Informal document **GRE-89-02/Rev.3**
(89th GRE, 24-27 October 2023,
agenda item 6)

Collation of proposals for the new [09] series of amendments to UN Regulation No. 48

According to the 88th GRE Report (doc. ECE/TRANS/WP.29/GRE/88, para. 22), GRE suggested that a consolidated text of the draft 09 series of amendments to UN Regulation No. 48 be prepared. GTB offered to prepare such a consolidation and submitted it to SLR for final check.

The above limits and the initial aiming values are summarized in the diagram below.

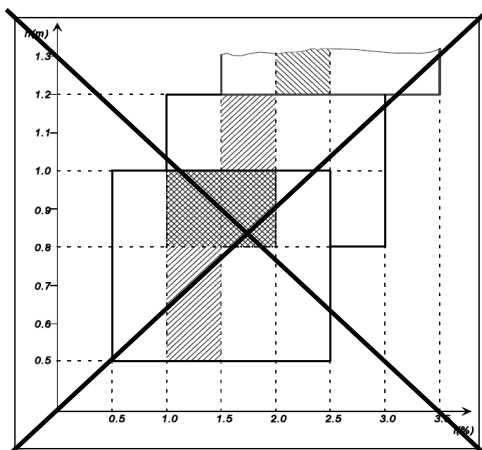
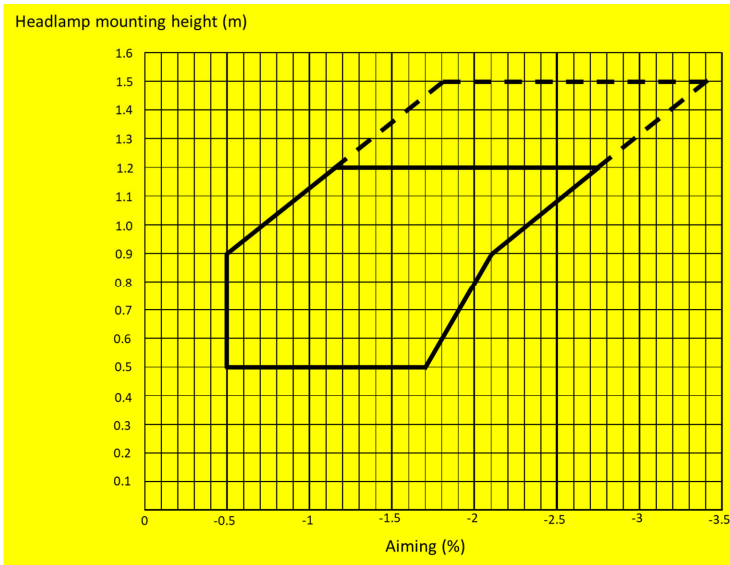
6.2.6.1.2. Vertical inclination limits of the cut-off

Depending on the mounting height in meters (h) of the lower edge of the apparent surface in the direction of the reference axis of the dipped-beam headlamp, measured on the unladen vehicles, the vertical inclination of the cut-off of the dipped-beam, starting from the initial downward inclination value set by the vehicle manufacturer as prescribed in paragraph 6.2.6.1.1., shall under all the static conditions of Annex 5, remain between the following limits and the initial aiming shall have the following values, under all the static loading conditions of Annex 5:

Mounting height h [m]	Upper inclination limit [per cent]	Lower inclination limit [per cent]
$0.5 \leq h \leq 0.9$	-0.50	$-(h + 1.2)$
$0.9 < h \leq 1.2$	$-(h \times 2.17 - 1.45)$	$-(h \times 2.17 + 0.15)$
$1.2 < h \leq 1.5$

For category N₂G (off road) vehicles, where the headlamps exceed a height of 1,200 mm the limits for the vertical inclination of the cut-off shall be between -1.5 per cent and -3.5 per cent

The area within the dashed line indicates the extension of the aiming diagram only valid for M₂G, M₃G, N₂G, N₃G (off-road) vehicles
